Access Compliance Report Public Rights-of-Way (Curb Ramps)

Main Street: TUSTIN_RANCH_RD Cross Street: IRVINE_BLV Location: NW

ADA ID: RPRK220103130403 Ramp Type: Type 1 - Perpendicular Diagonal Initial Pass/Fail: Pass Overall Compliance: No Severity Score: 0

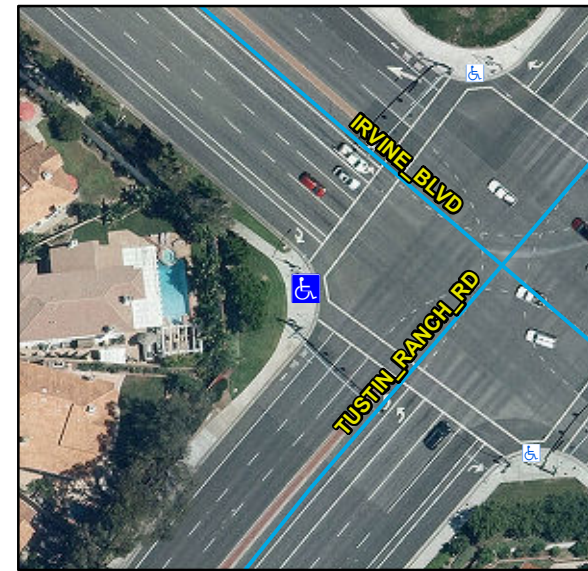
Yes	Ramp Inside Crosswalk 1	Yes	Yes	Ramp Inside Crosswalk 2	Yes
	Crossing 1 Slope (%)	2.8		Crossing 2 Slope (%)	2.5
	Crossing 1 Cross Slope (%)	0.3		Crossing 2 Cross Slope (%)	0.4
Yes	Gutter Ponding	No	Yes	Curb Slope	3.7
Yes	Gutter Lip Height (in)	0		Road Run Slope (%)	2.4
Yes	Gutter Run Slope (%)	4.8		Road Cross Slope (%)	3.7
No	Gutter Cross Slope (%)	2.5			
Yes	Overall Surface Condition: Acceptable		Yes	Perp Joint Present	Yes
	Cross Gutter Present?	No		Spandrel Present?	No
	Replace Cross Gutter?	N/A		Replace Spandrel?	N/A

Possible Solutions:

Remove & Replace Gutter.

R304.5.3, STD 1115
